AMENDMENTS TO THE DRAWINGS:

REMARKS

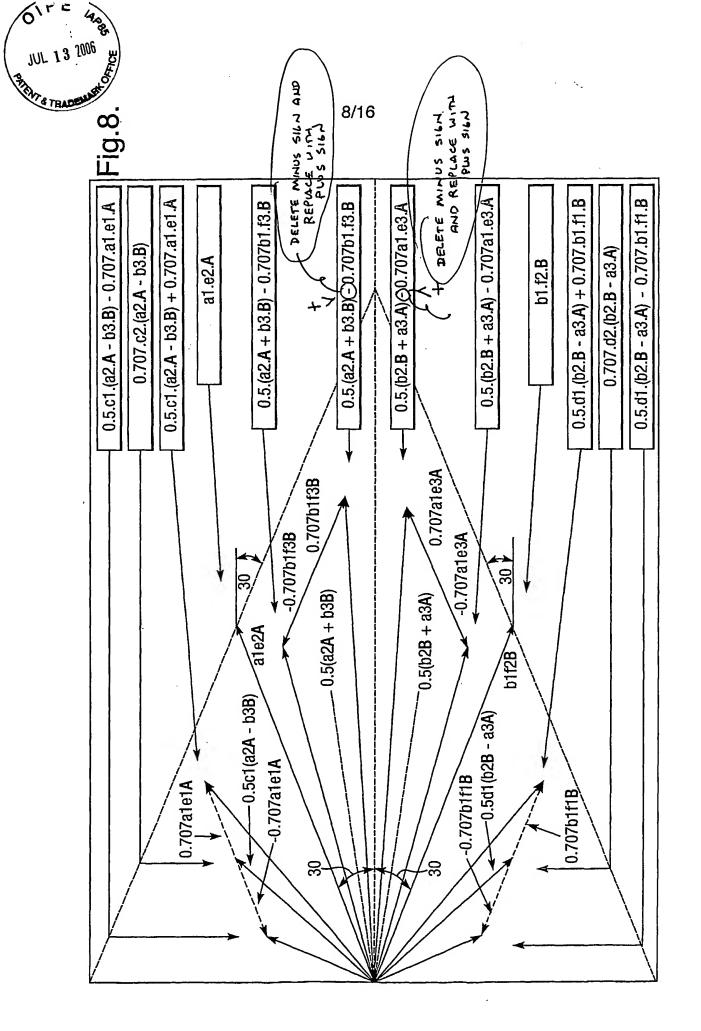
The attached drawing sheets include amended and marked-up versions of Figure 8. Figure 8 has been amended to change several minus (-) signs to plus (+) signs.

Figure 8 is amended in two instances to change minus signs ("-") to plus signs ("+").

This amendment is supported by vector diagrams (arrows indicating vectors in magnitude and

direction) adjacent to the left side of the amended Figure 8 boxes, which show 0.707b1f3B being

added to 0.5(a2A + b3B) and 0.707a1e3A being added to 0.5(b2B + a3A) respectively.
